**Technical Publication
Transfer Test with
McDonnell Aircraft Company:
MIL-M-28001 (SGML) and
MIL-D-28000 Class I (IGES)**

June 25, 1990

Prepared by
Syscon Corporation
and Lawrence Livermore
National Laboratory

Exhibit 5: MCAIR's Illustration 41 as originally drawn and plotted.
(Size reduced from a fold-out to a single page.)

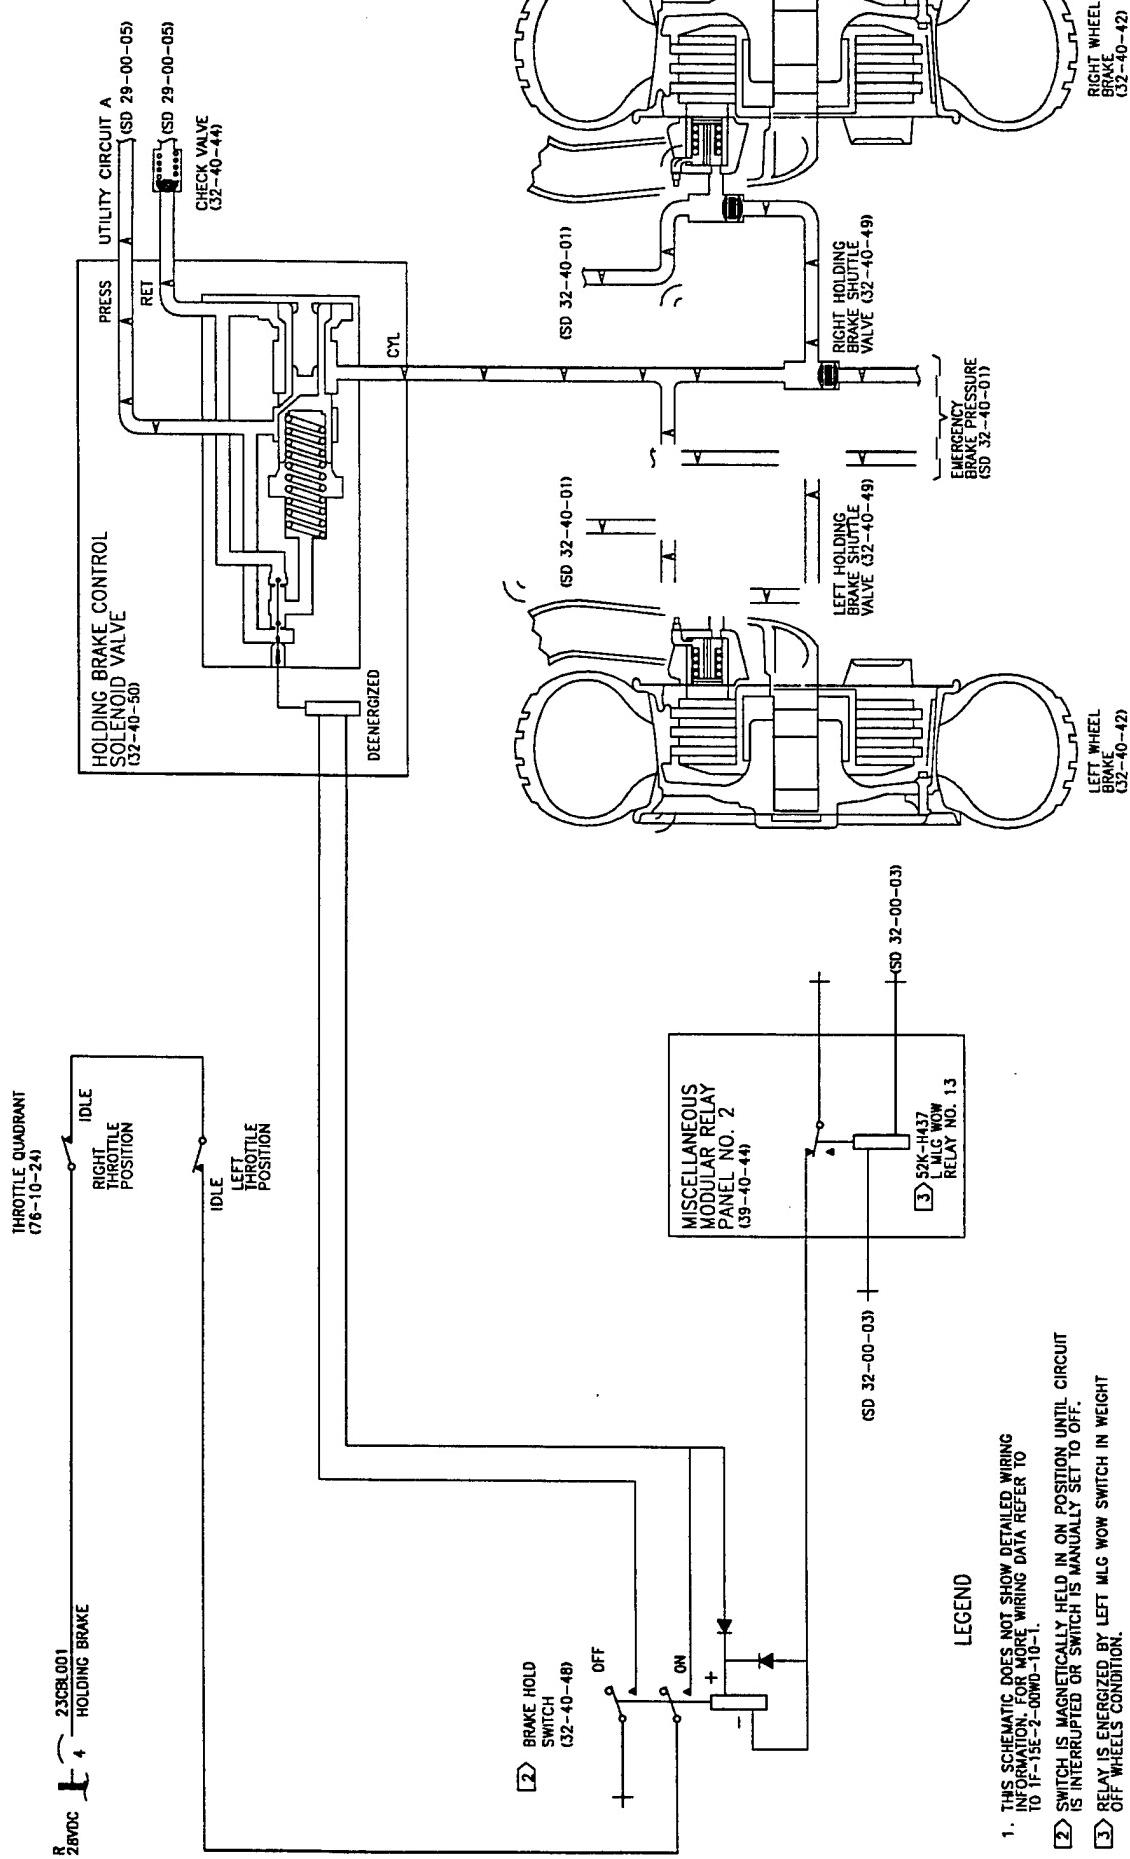
Note the missing crosshatching, the misplaced subfigures and piping styles that are represented with text. (Size reduced from a fold-out to a single page.)
